ADDENDUM 1

DATE: 01/30/18
PROJECT: UCT Expansion Interior Buildout
RFP NO: RFP 744-R1805 – UCT Expansion Interior Buildout
OWNER: The University of Texas Health Science Center at Houston
TO: Prospective Proposers

A401

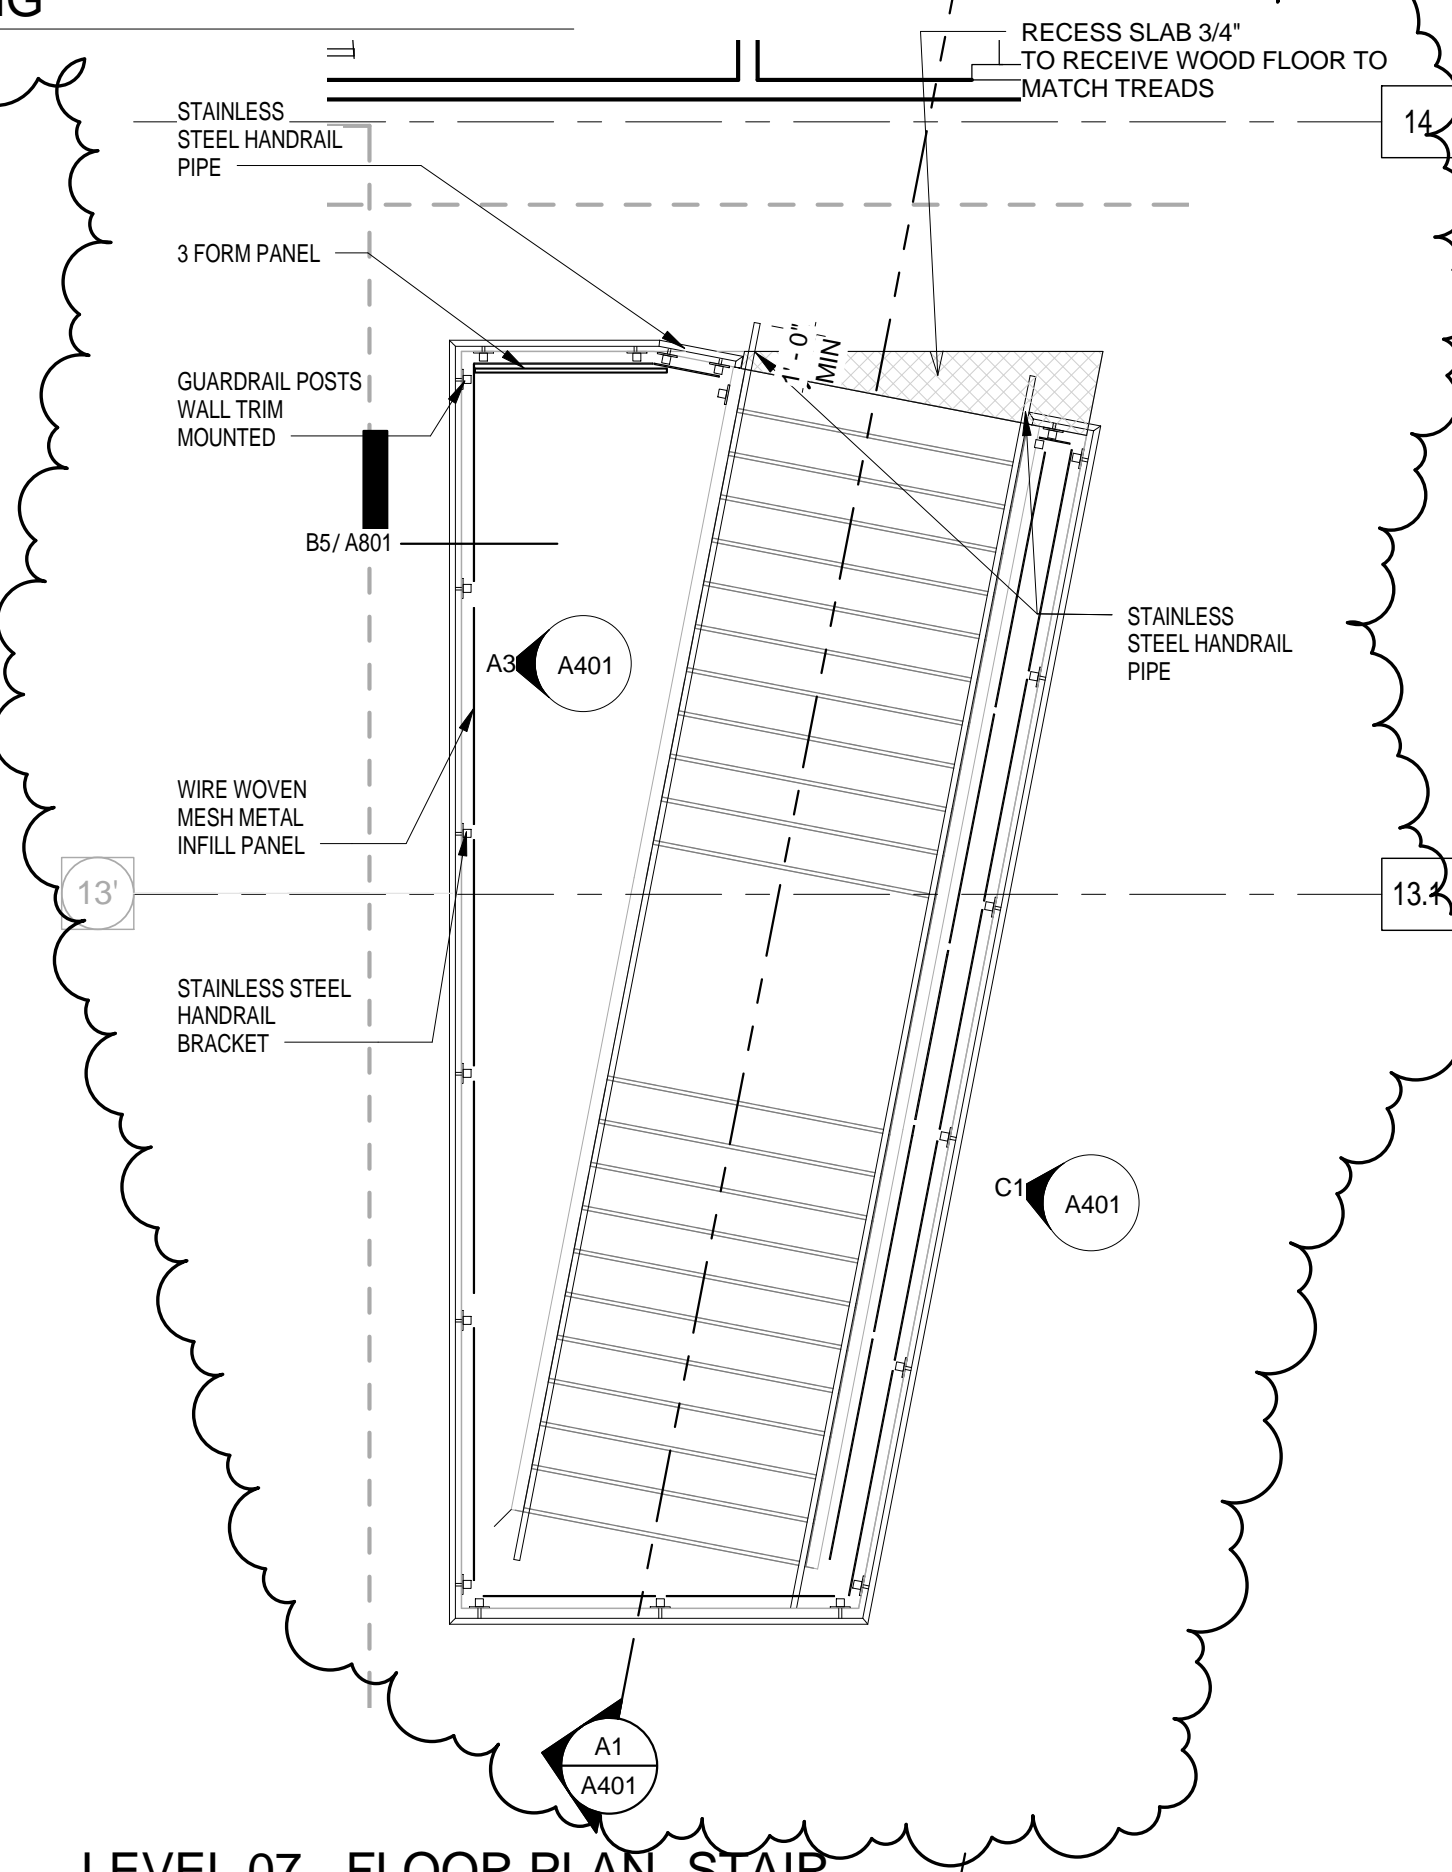
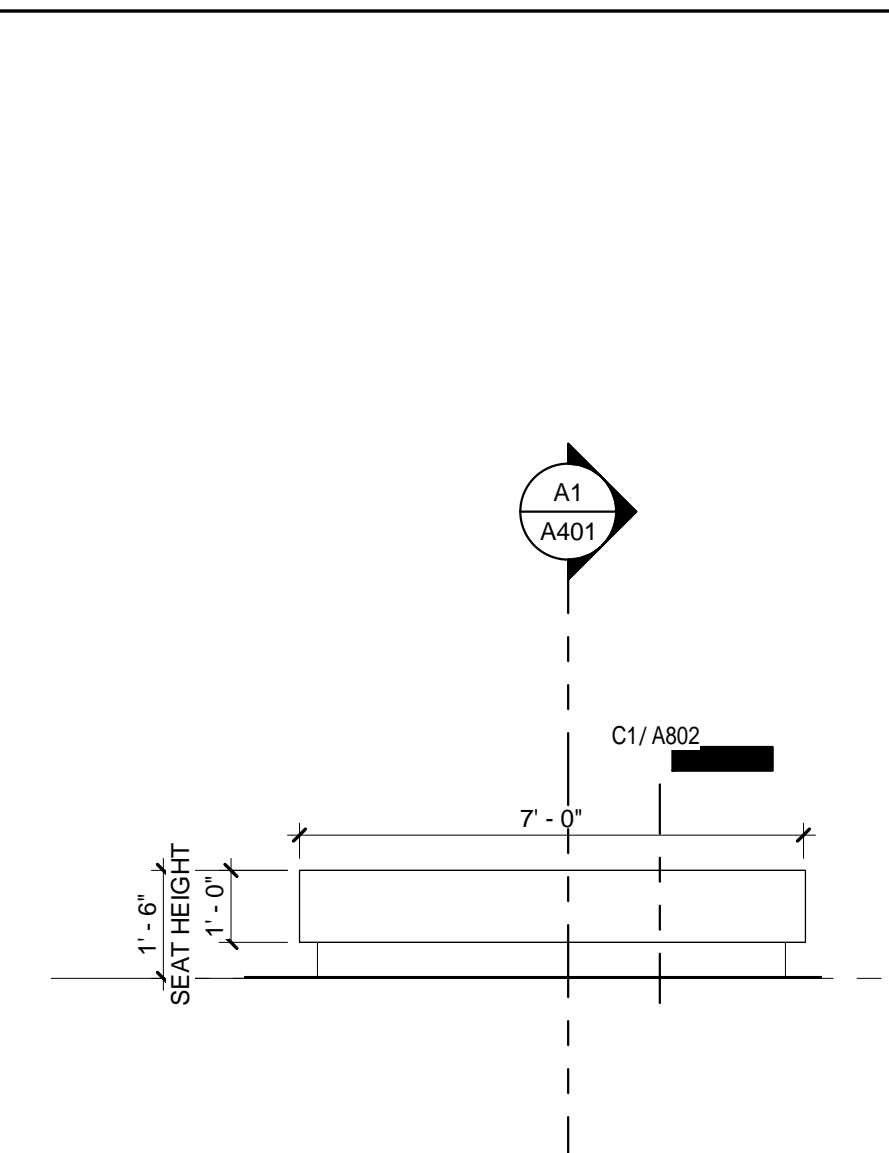
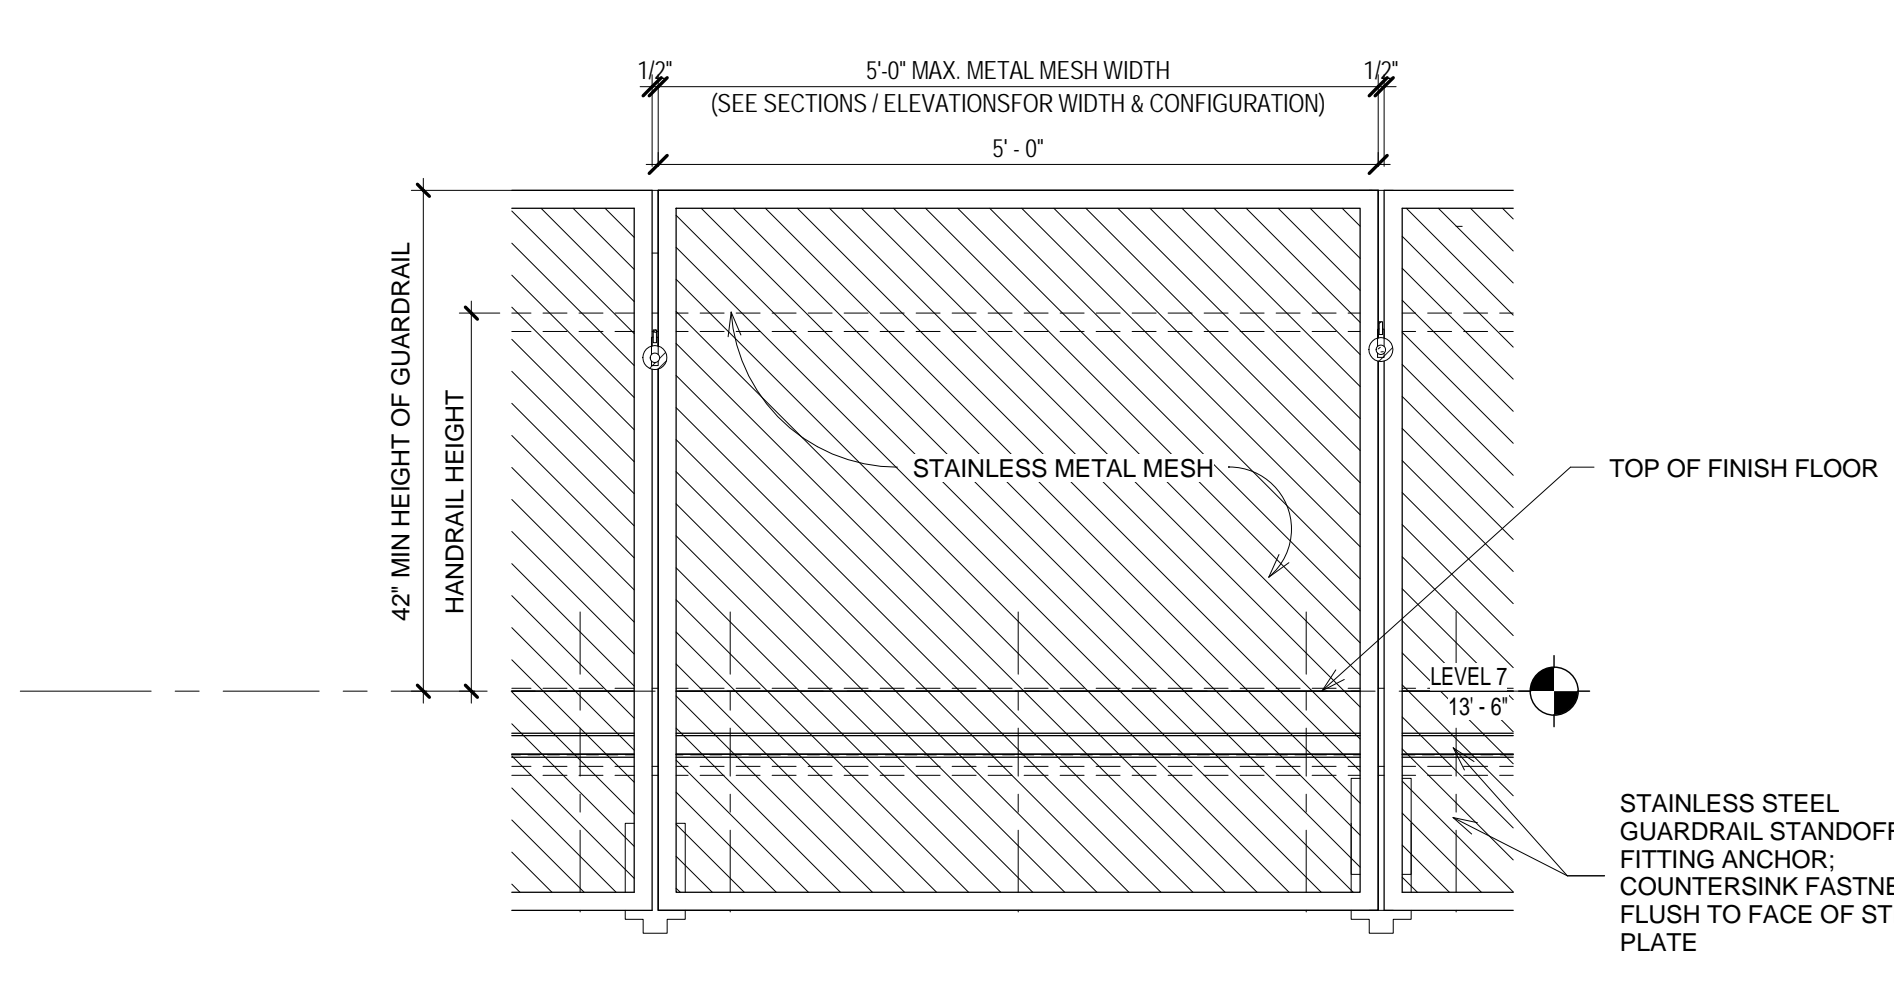
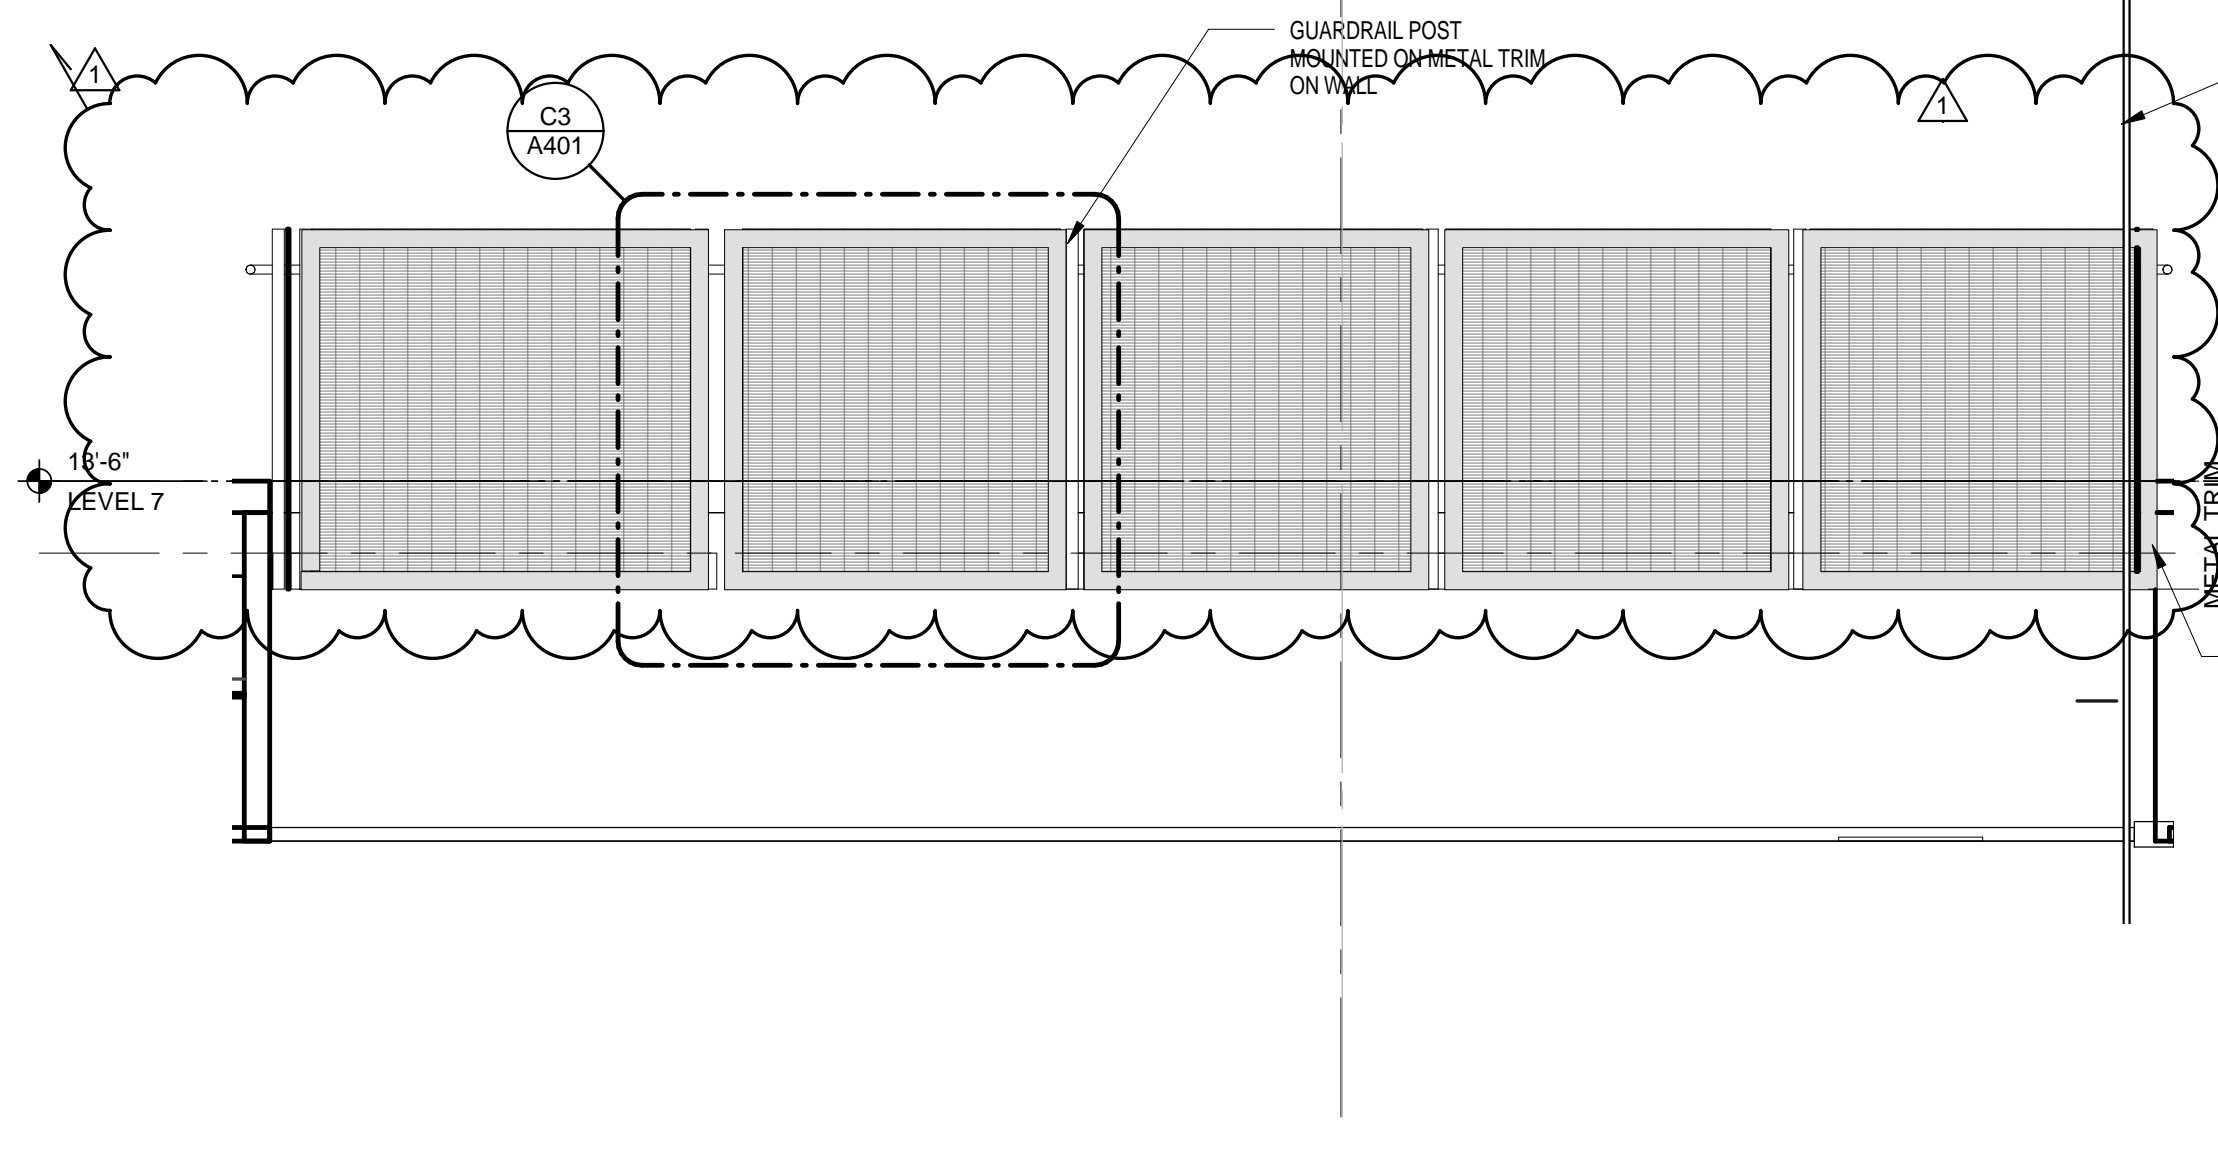
31. Sheet A401 – Please provide the following clarifications:

a. Detail C1 – Please provide detail for Guard Rail Stainless Steel “Flat and Angle Frame”

b. Detail C3 – Please clarify how mesh support tubes are mounted to the stringers.

c. Detail C3 – Detail indicates stainless steel fascia. Please clarify if this fascia is existing or part of this project installation. If part of this project, please provide details and location of stainless steel fascia.

d. Please clarify handrail. Details A1 & C1 indicate a single line rail, while A3 & D1 indicate a 4-line rail.

32. Sheet A401 – Detail C5 indicates wood flooring to match existing stair treads. Please provide wood floor material selection and specifications.

a. Is the extent of the wood flooring to be the hatched square shown in this detail only?

Provided

Vertical Support tubes to be mounted on stair stringer see drawing for notes

Stringer part of the core and shell project. No Steel Fascia to be used.

Single line handrail is to be provided

All details to be provided in Addendum 1 documents

Flooring and treads will be added into the interior Buildout set in an Addendum.
1 1/2" WALNUT WOOD TREAD
